STATE OF NEW MEXICO
ENERGY AND MINERALS DEPARTMENT
OIL CONSERVATION DIVISION

November 30, 1983

An exception, to tie back cement on the production string,
is granted for your BDCDGU Well No. 2033 011G located in
Unit G of Section 1, Township 20 North, Range 33 East,
Harding County, New Mexico.

Re: Cementing Programs
Bravo Dome Carbon Dioxide Gas Unit (BDCDGU) No. 2033 011G
Undesignated Tubb
Harding County, New Mexico

GAMMA	DEPTH	AMPLITUDE	
API Gamma Ray Units 100		Pipe Gate	MICRO-SEISMOGRAM® LOG
200		Formation Gate	100 Micro-Seconds 1100

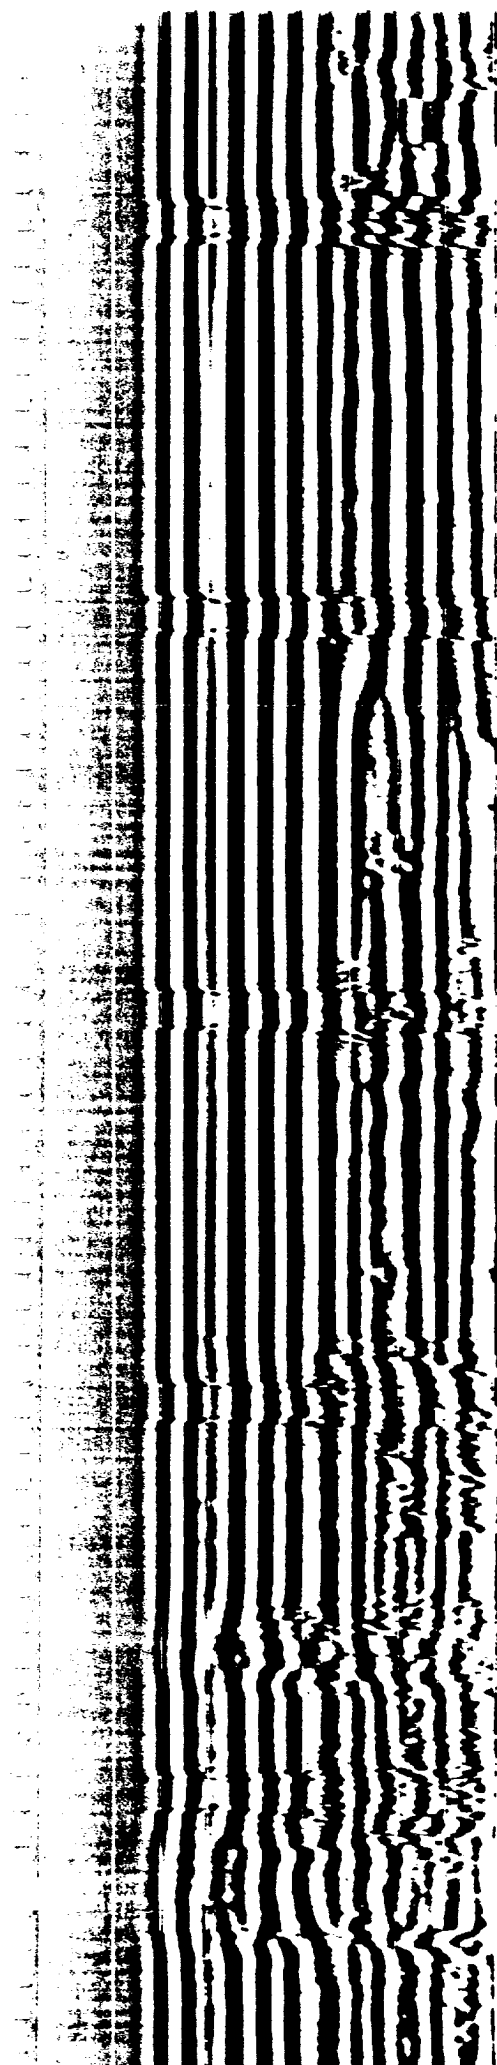
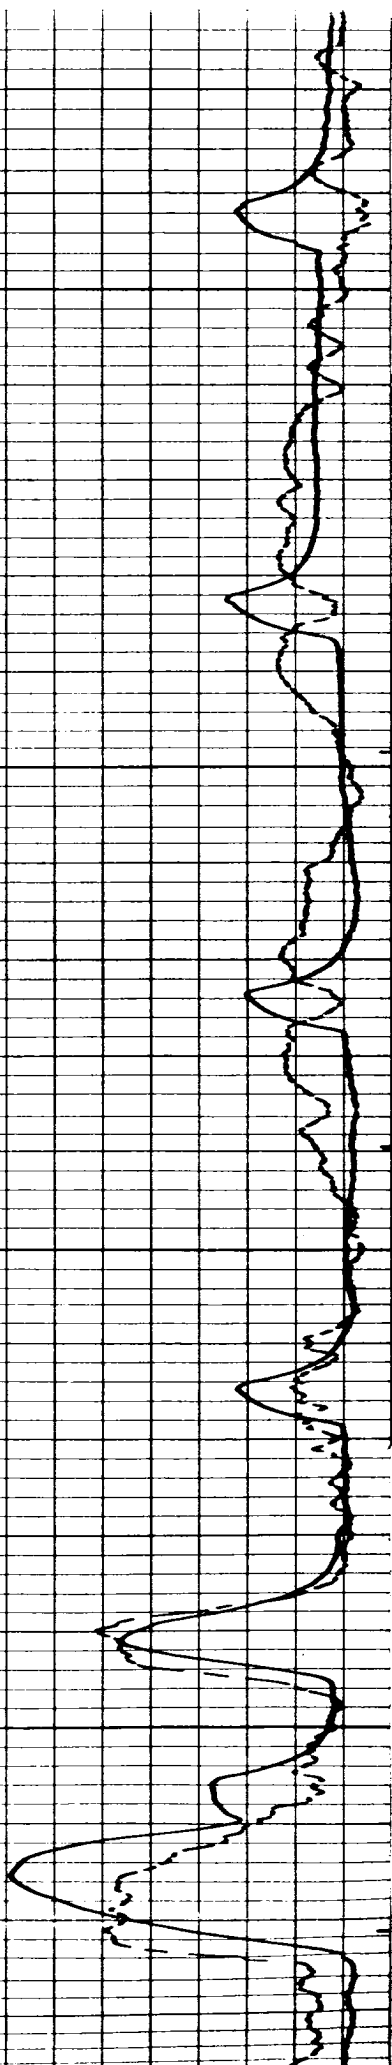
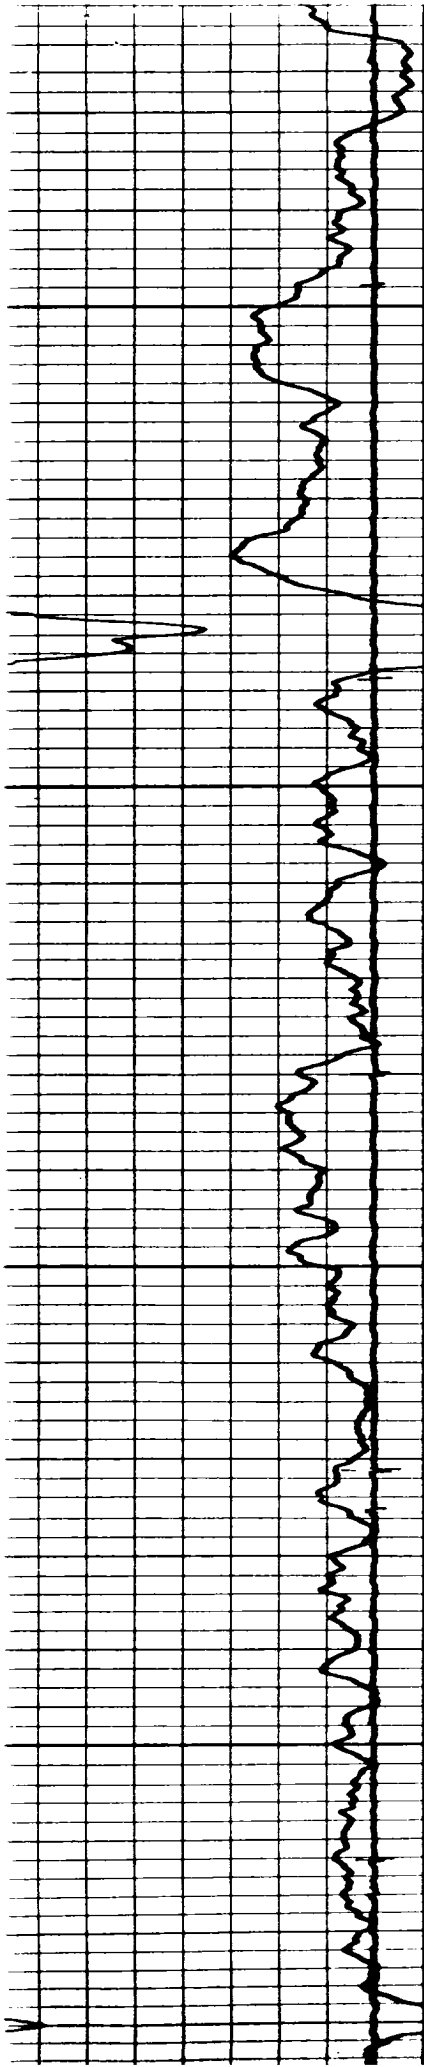
The well was then completed in the Tubb formation during which time a cement bond log was run from 1481' to 500' (See Attachment). The bond log showed that an excellent bond (hydraulic seal) exists from the bottom-most logged interval up to about 1270', from 1085'-1105' and from 1020'-1065'. Moderate bonding exists up to approximately 920'. Additionally, several cement bridges exist up to the surface casing point which provide hydraulic seals. These uphole bridges have been confirmed by unsuccessful attempts to establish circulation during tie-back operations.

As a result of these "cement bridges" (hydraulic seals) up to the surface casing point and in light of efforts made to date, additional cement tie-back work is unnecessary. Effective hydraulic seals exist between both the Tubb (2294') and Glorieta (1822') formations with other uphole formations and the surface. Request your approval be granted to discontinue further tie-back operations.

You have made a diligent effort to accomplish this work
and apparently have good cement over the appropriate forma-
tions.
